A D D E N D U M N O . 1

MAGNOLIA BEACH FIRE STATION PROJECT

CALHOUN COUNTY, TX

March 12, 2026

SHT. NO. C9.2

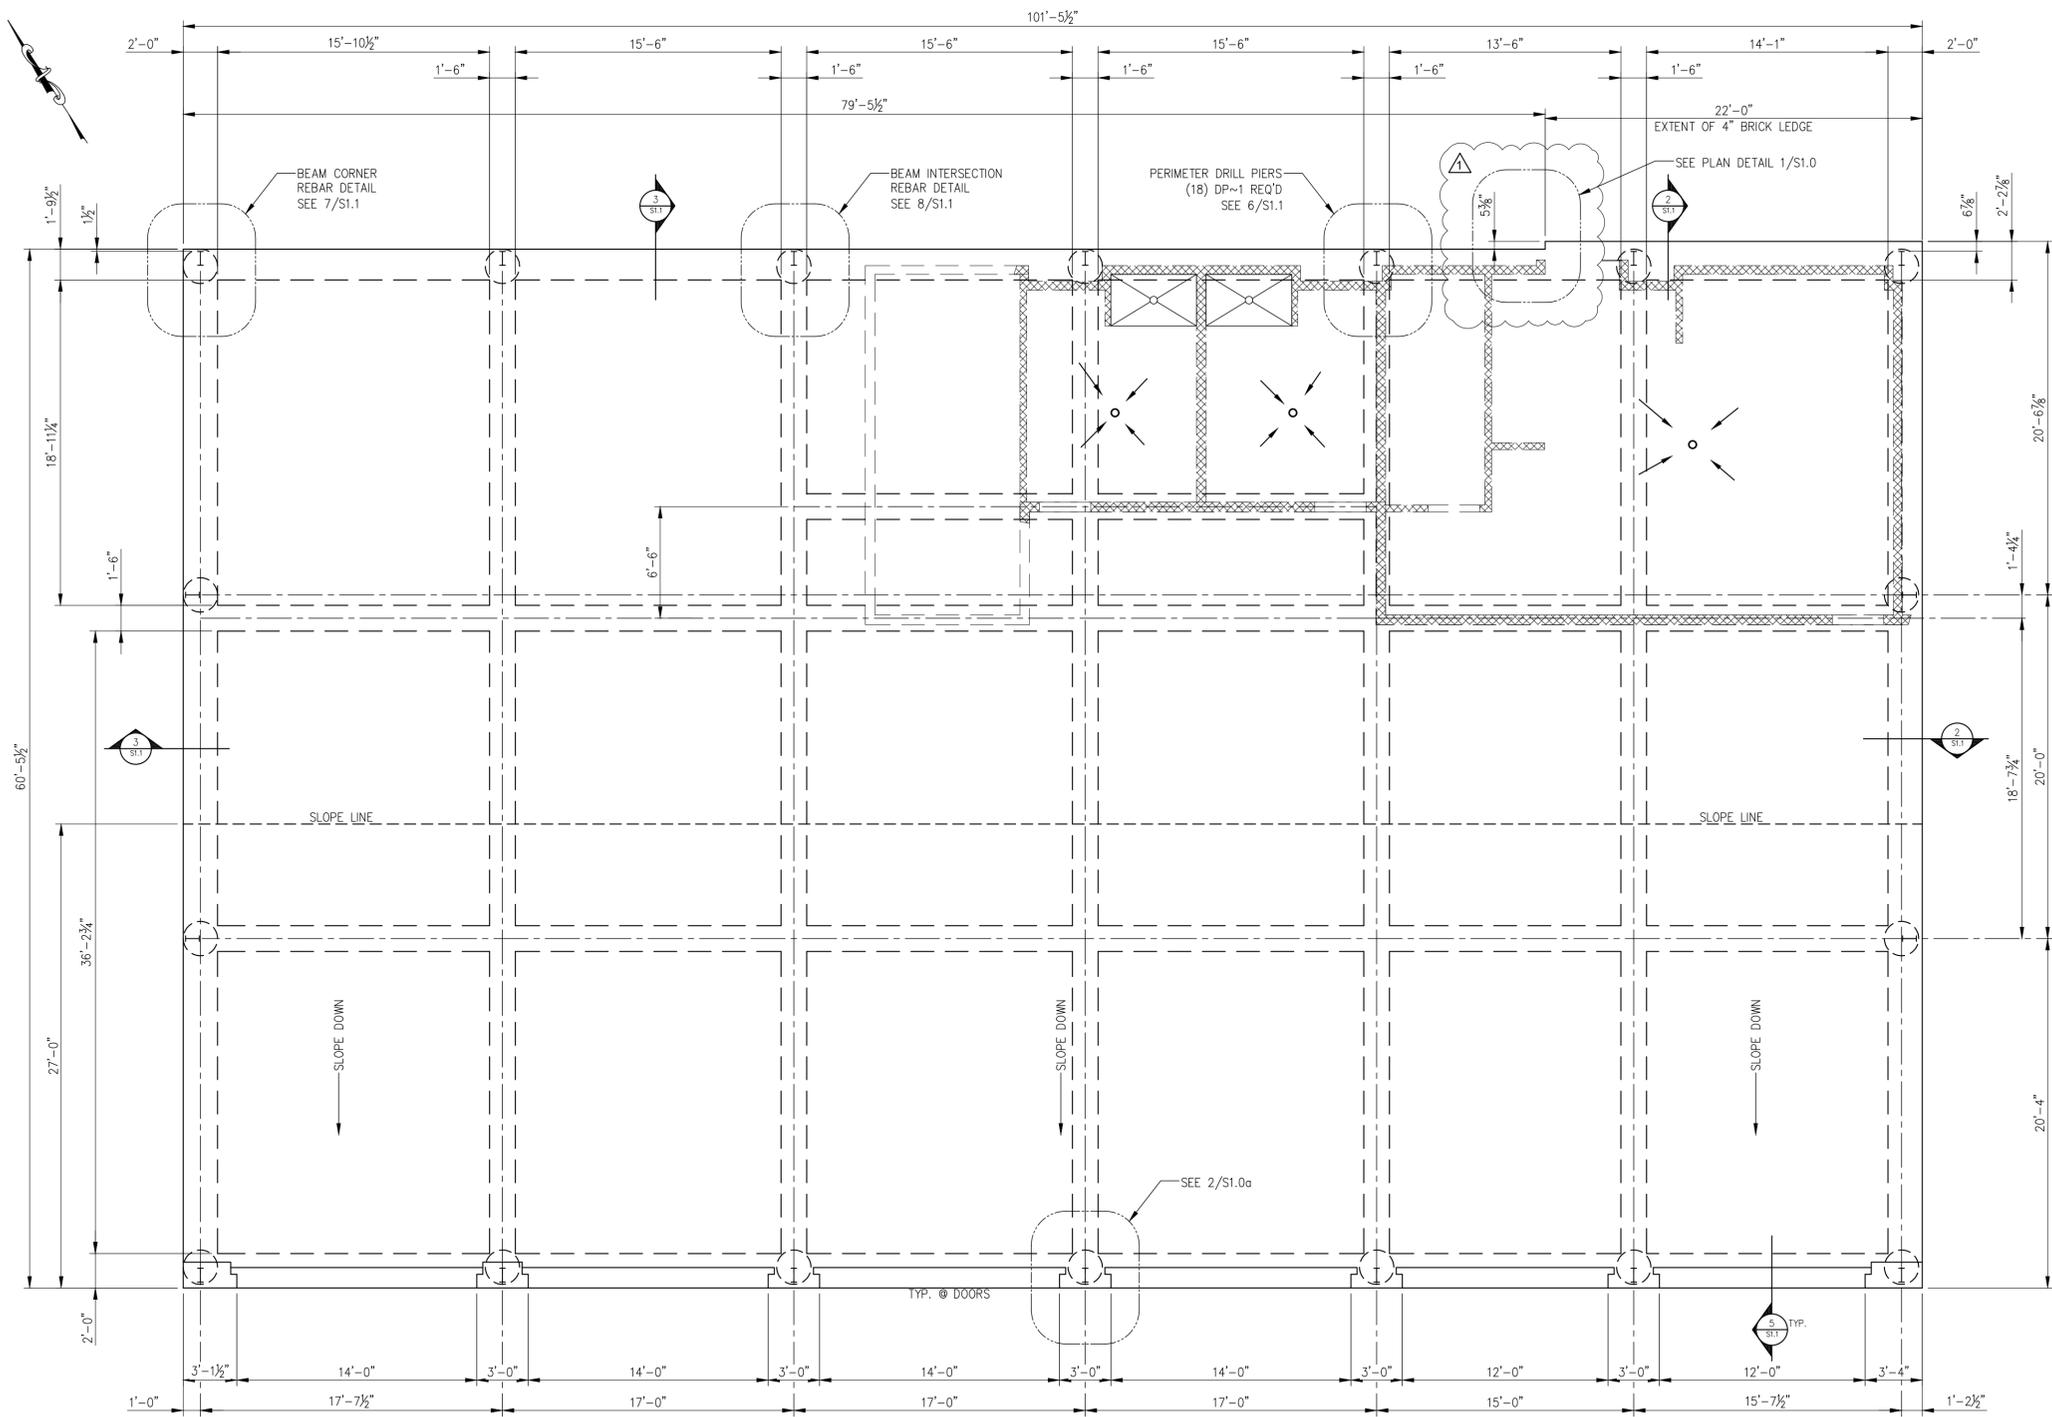
EXPLANATION: C9.2 – Corrected Notes, Table and Detail 9.
S1.0 – Corrected dimensions and revised/added notes.
S1.1 – Corrected dimensions and added note.
A1.1 – Revised General Notes
A1.2 – Revised Door “D” note.
A1.3 – Revised Insulation Notes
A1.4 - Added note for blind requirements.
A1.7 – Modified Notes and updated call outs.
A1.8 – Modified Notes and updated call outs.
A1.9 – Updated call outs.

1
S1.0 FOUNDATION PLAN
SCALE: 3/16" = 1'-0"

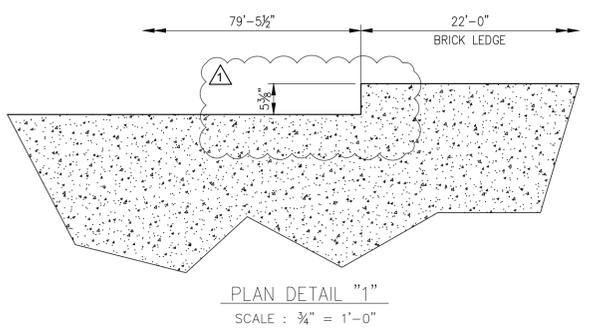
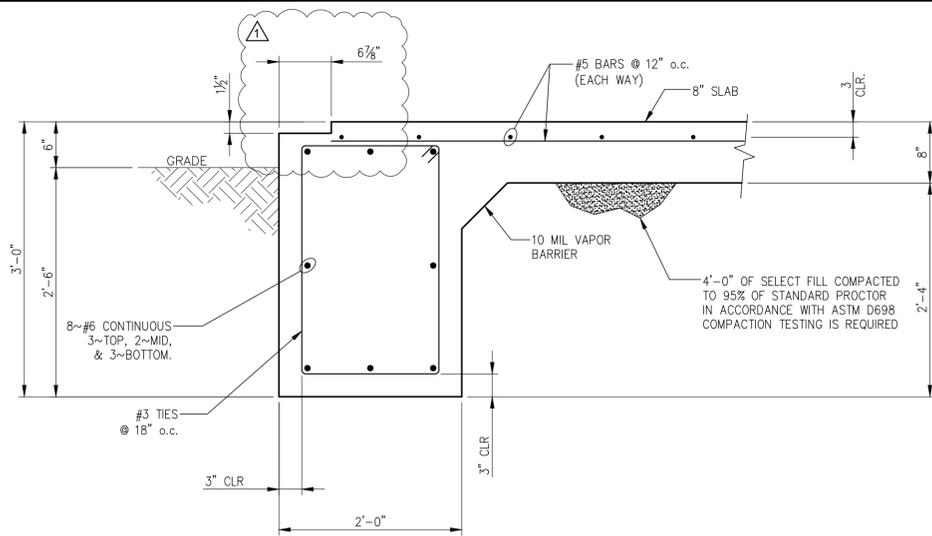
After reviewing the plans subcontractors have not found true clarifications on the TDI requirements. Project location is on the coast, and the drawings do state UL rated Class 90 for the roof but not sure if that is correct. Additionally, the plans calls for the roof to be R-Panel “exposed fastener” but to be compliant with any TDI requirements we will be needing to bid the job as a standing seam. Is that something you feel you could agree and address?

Answer: The TDI wind design requirements have been moved from Sheet A1.1 on the plans to Sheet S1.0. They are also included within Technical Specification 13121, section 2 “Design Loads”. We have modified the roof and side paneling to be PBR Panels and there are options available through TDI website with product evaluations that meet the requirements of the project with the exposed fasteners. It will be up to the PEMB engineer to specify the proper fasteners, fastener spacing to meet the requirements of the design criteria.

1 DOOR SCHEDULE
A1.2 SCALE : 1/4" = 1'-0"

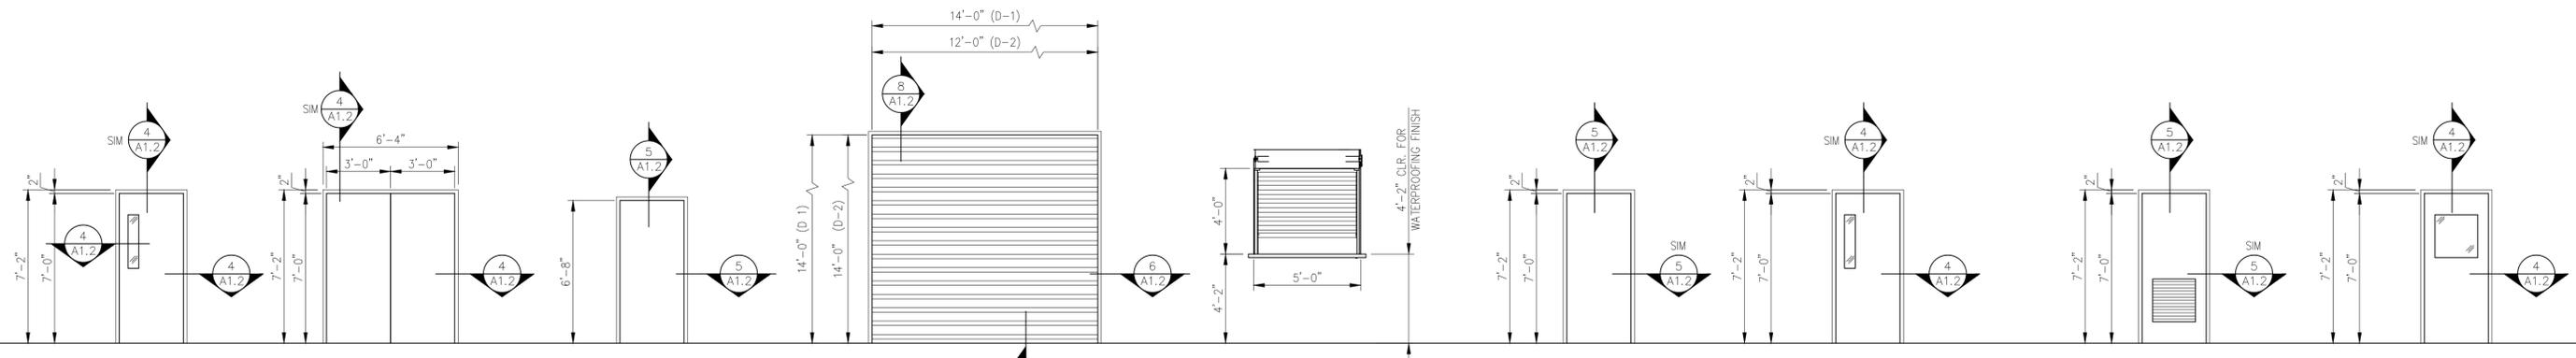
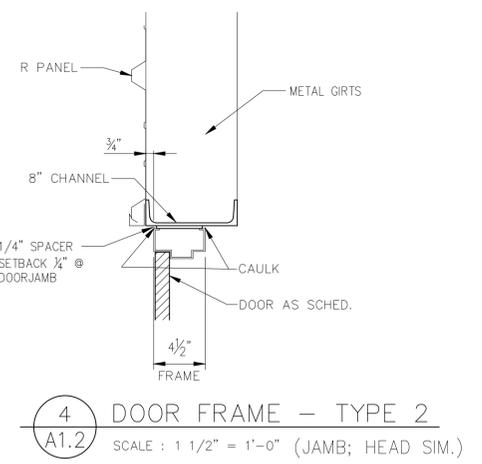
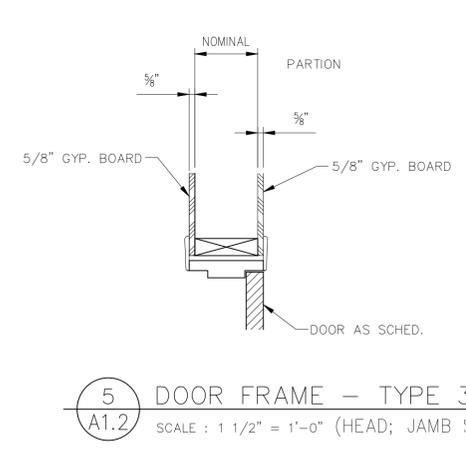
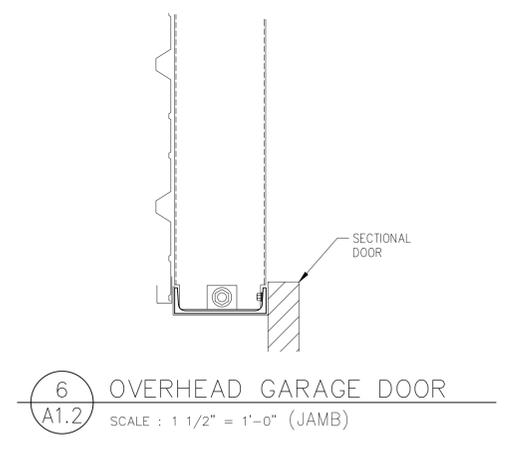
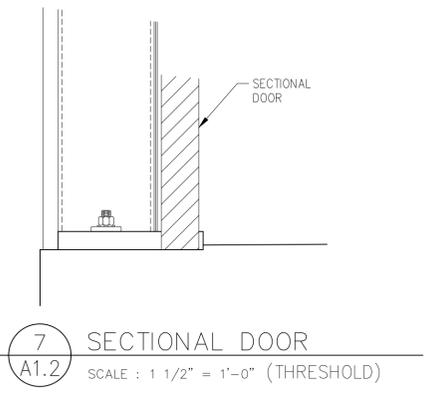
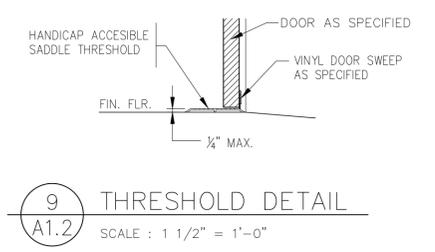
For the overhead coiling doors on sheet A1.2, will there be a spec section for them?

Answer: The garage doors are specified in the plans to be a sectional door. The specifications can be found on the applicable detail calling out the brand and model number or equal. The door specified will have to meet the requirements of TDI.
